SUBDIVISION WITHOUT PLAT APPLICATION

APPLICATION STAFF COMMENTS

Project Name/Business Name: All R Friends

Development Plan Review Response 2017052601 Revision

Original Elevation

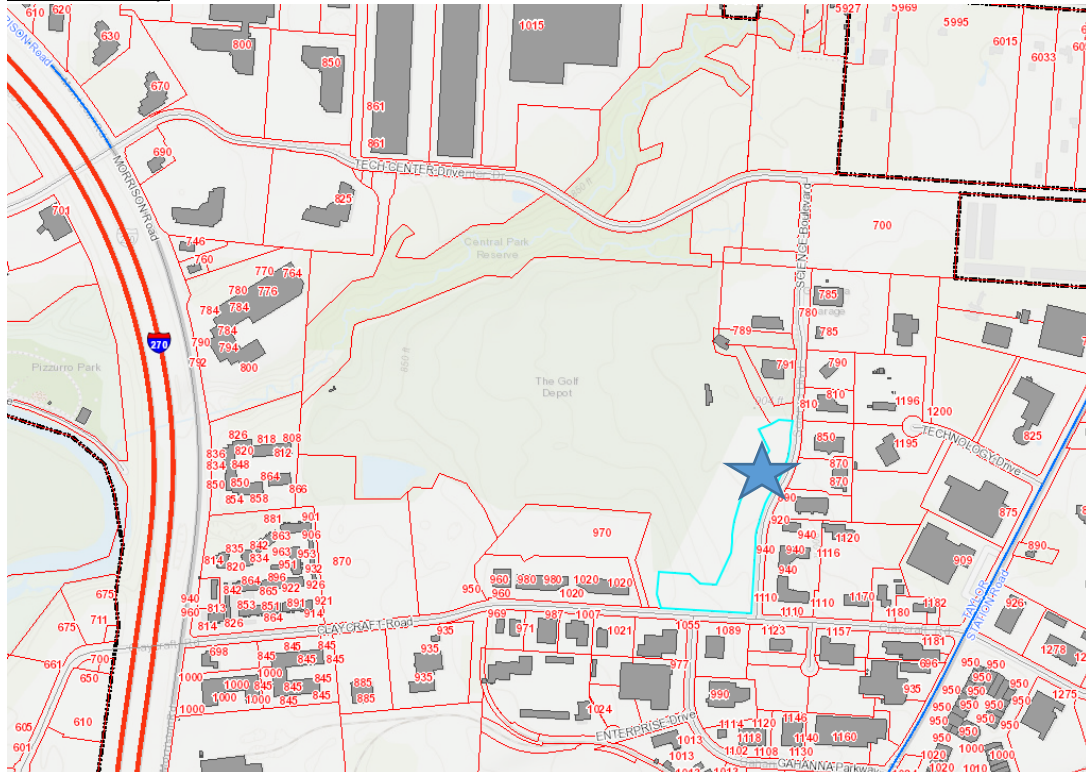
- a) 40%-70% of the main façade for office uses shall be window openings.
An updated rendering has been provided. It appears that the main façade (east elevation) meets the aforementioned requirement.
- b) All buildings shall provide a minimum tree planting within the interior of the site to help provide shade and increase aesthetic value. Trees shall be a minimum of 2" in caliper.
An updated site plan has been provided. The tree size, 2 ½", meets the requirements of the overlay.
